UCSI ENGINEERING CHANGE NOTIFICATION FORM

Title: Add SET_CAM_PRIORITY Command
Applied to: UCSI Specification Version 3.0 Revision 1

Adds a new command for the OPM to set alternate mode priorities in the LPM.

Figure 1. OPM mode selection

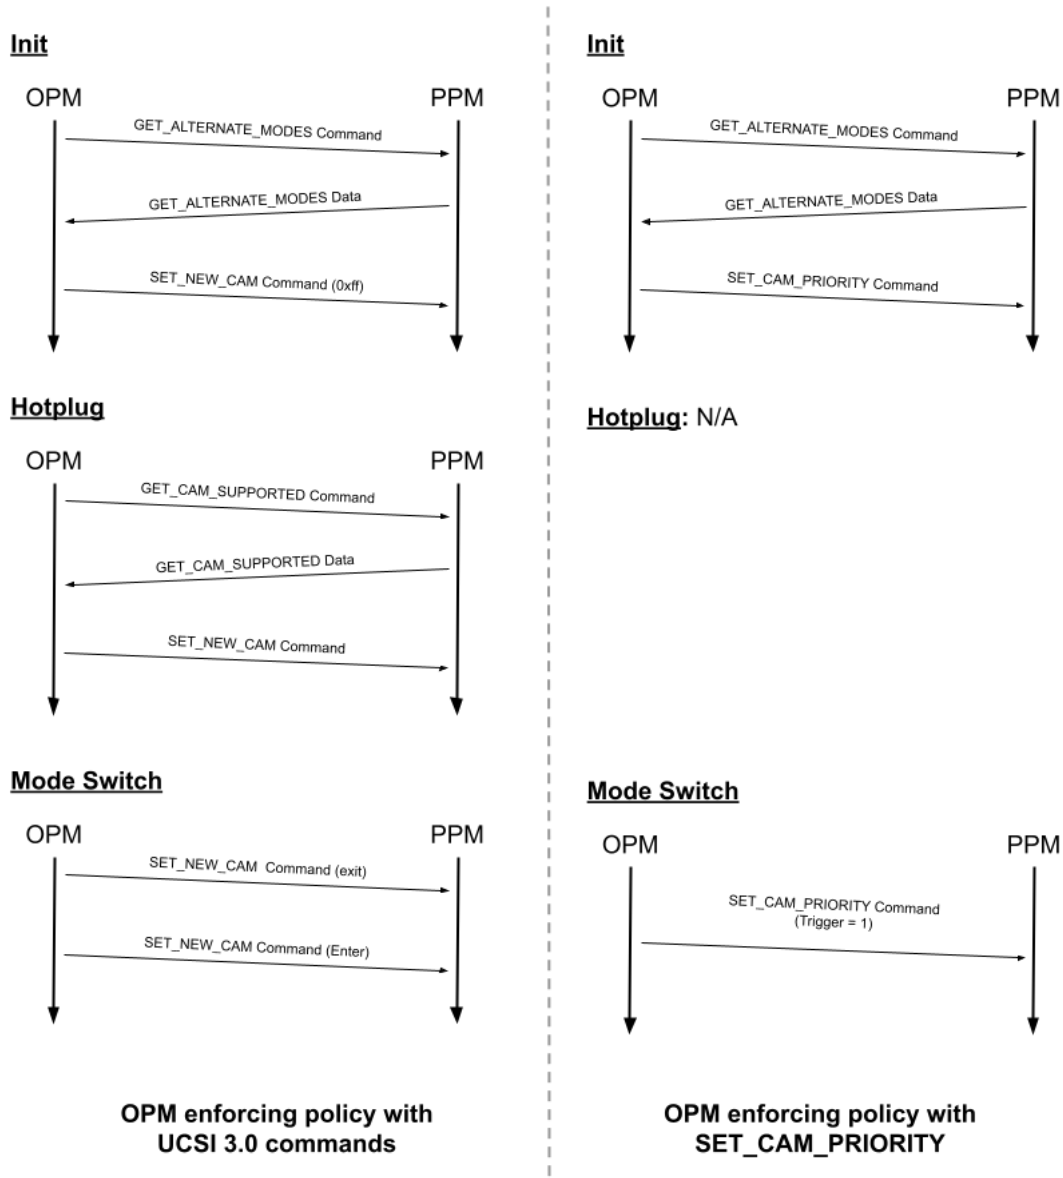
Either SET_CAM_PRIORITY or the existing UCSI 3.0 commands can be used by the OPM to enforce a mode entry policy. Figure 1 shows how the two sets of commands compare during initialization, hotplug and mode switching.

During initialization, the OPM needs to send `GET_ALTERNATE_MODE` to know which alternate modes the connector supports. For UCSI 3.0, the OPM should then send `SET_NEW_CAM` (0xff) to prevent the LPM from auto-entering alternate modes. With `SET_CAM_PRIORITY`, the OPM should send the command on initialization to set the default mode entry policy. On hotplug, an OPM using UCSI 3.0 commands must send `GET_CAM_SUPPORTED` to know which alternate modes are available then send `SET_NEW_CAM` to enter the desired mode. With `SET_CAM_PRIORITY`, no command needs to be sent by the OPM on hotplug. To switch modes with UCSI 3.0 commands, the OPM must send 2 `SET_NEW_CAM` commands: One to exit the current mode and another to enter the desired mode. With `SET_CAM_PRIORITY`, the OPM must send one command with the Trigger mode field set to 1.
